Report to the Future Melbourne (Planning) Committee

Agenda item 6.1

Planning Permit Application: TP-2020-274
54-62 Bourke Street, 11-19 Liverpool Street and
Shop 9, 10-26 Crossley Street, Melbourne

8 December 2020

Figure 11: Liverpool Street elevation of Jobs Warehouse. New opening marked by yellow arrow (source: application plans prepared by Point Architects)

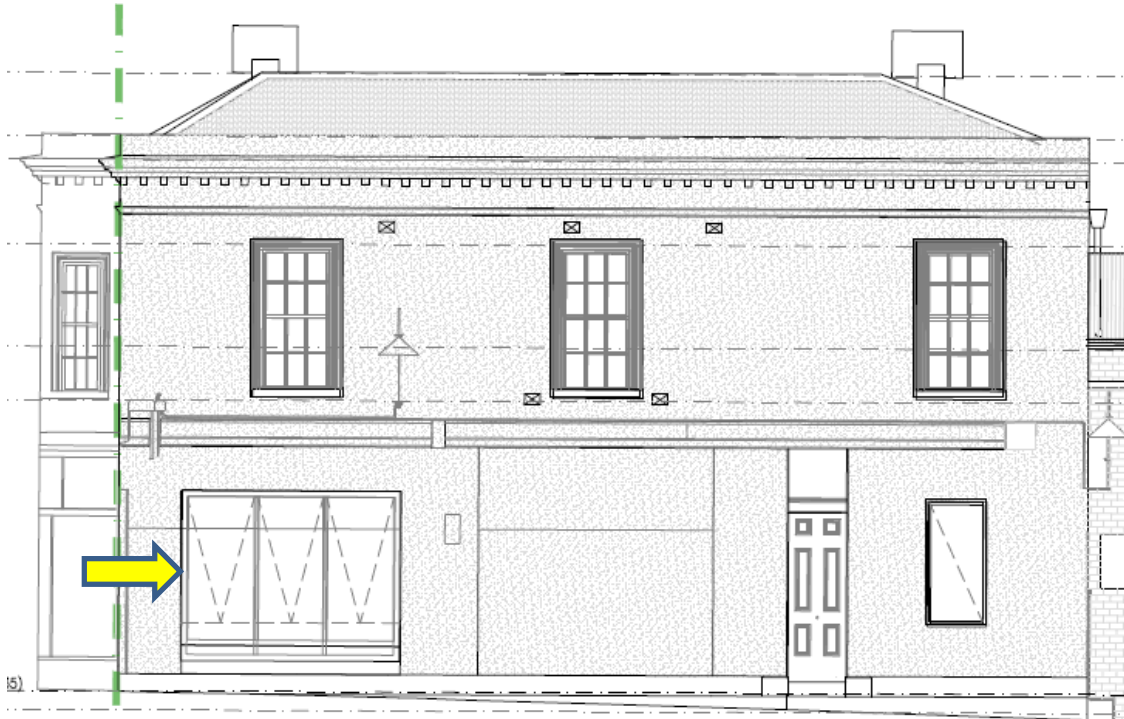
Though a permit is not required for this opening in accordance with the provisions of the HO (on the basis a permit has previously been granted by HV), the provisions of DDO1 nevertheless apply. Again, this schedule requires the activation of streetscapes and the proposed opening will certainly allow for this together with the existing retained openings along the Bourke Street frontage.

Figure 11 below shows this new opening in greater detail.
